## DEVELOPMENT APPLICATION ASSESSMENT REPORT

<b>Application Number:</b>	DA2021/1146
----------------------------	-------------

<b>Responsible Officer:</b>	Gareth David
<b>Land to be developed (Address):</b>	Lot 122 DP 29010, 35 Kanimbla Crescent BILGOLA PLATEAU NSW 2107
<b>Proposed Development:</b>	Alterations and additions to a dwelling house
<b>Zoning:</b>	E4 Environmental Living
<b>Development Permissible:</b>	Yes
<b>Existing Use Rights:</b>	No
<b>Consent Authority:</b>	Northern Beaches Council
<b>Land and Environment Court Action:</b>	No
<b>Owner:</b>	Hilde Rutherford Adam Anthony Rutherford
<b>Applicant:</b>	Hilde Rutherford

**Figure 1: Height of building variation highlighted in green**

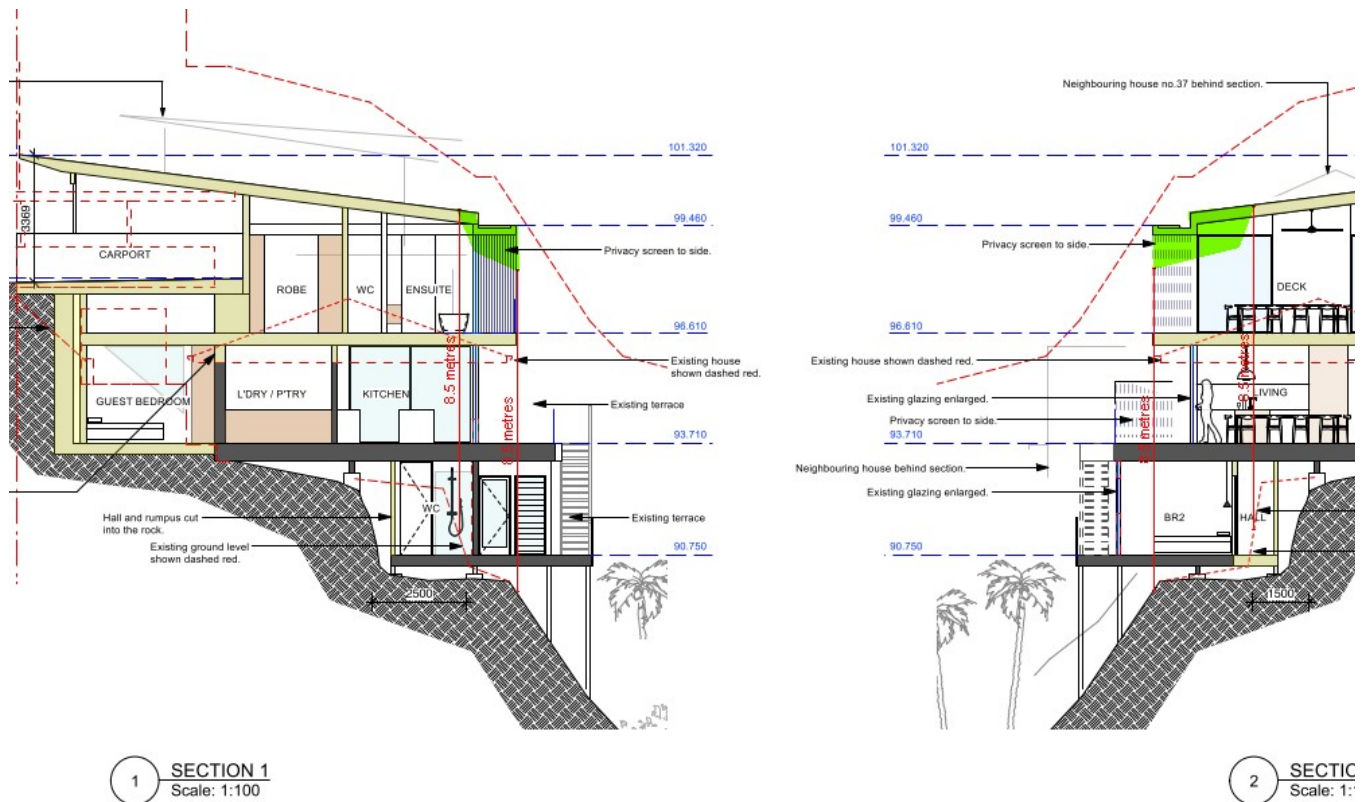
The variation to the 8.5m height limit is not excessive and is demonstrated in Figure 1 below. As shown the extent of the variation is predominantly limited to the roof form and upper portion of the "level 1" balcony enclosing wall and privacy screening on the outer eastern and western elevation.

**Figure 2: View angles over the subject site**

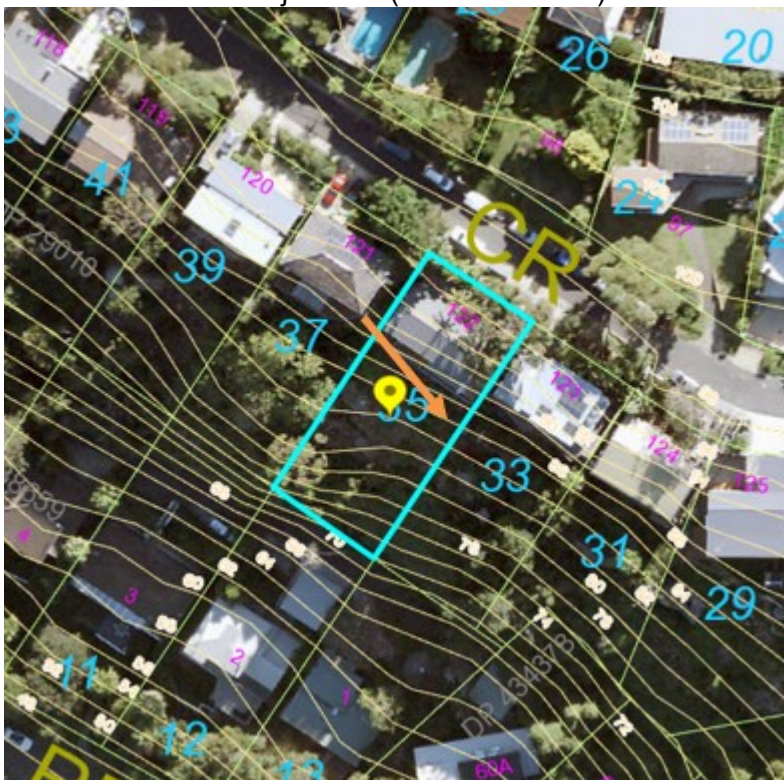
Figure 2 below shows the origin of the submissions relative to the subject site, and the view angles of the sites over the subject site (outlined in blue).

**Figure 5 - Proposed building envelope non-compliance on the eastern elevation (highlighted in green).**

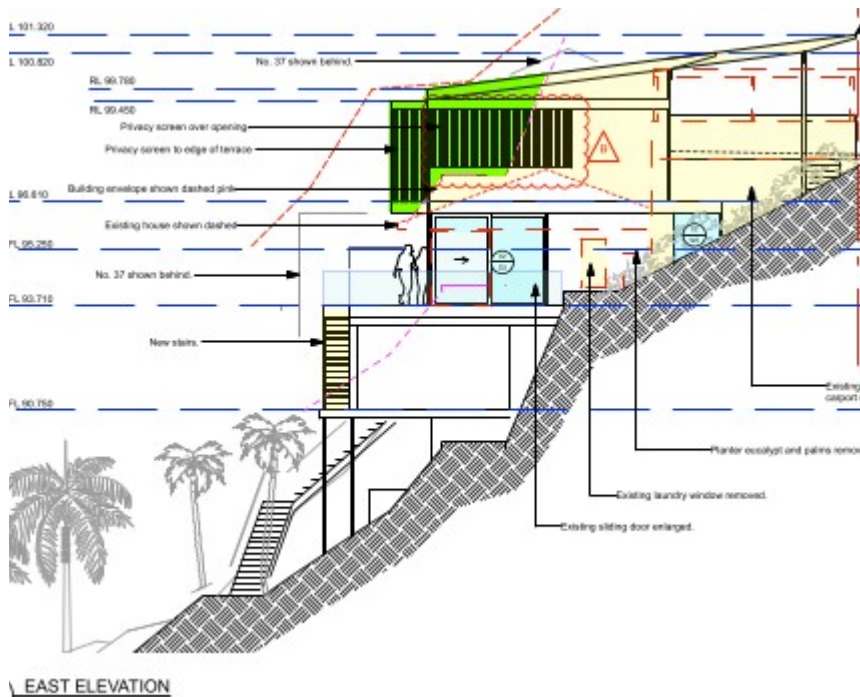
The proposed dwelling additions has a encroachment into the prescribed building envelope along the eastern and western elevations. This variation is represented in figure 1 and 2 below.

This building envelope non-compliance is largely attributed to the slope of the site, which exceeds 30%. P21DCP allows for a variation to the prescribed building envelope for development on steep sites, subject to consistency with the outcomes of this Clause.
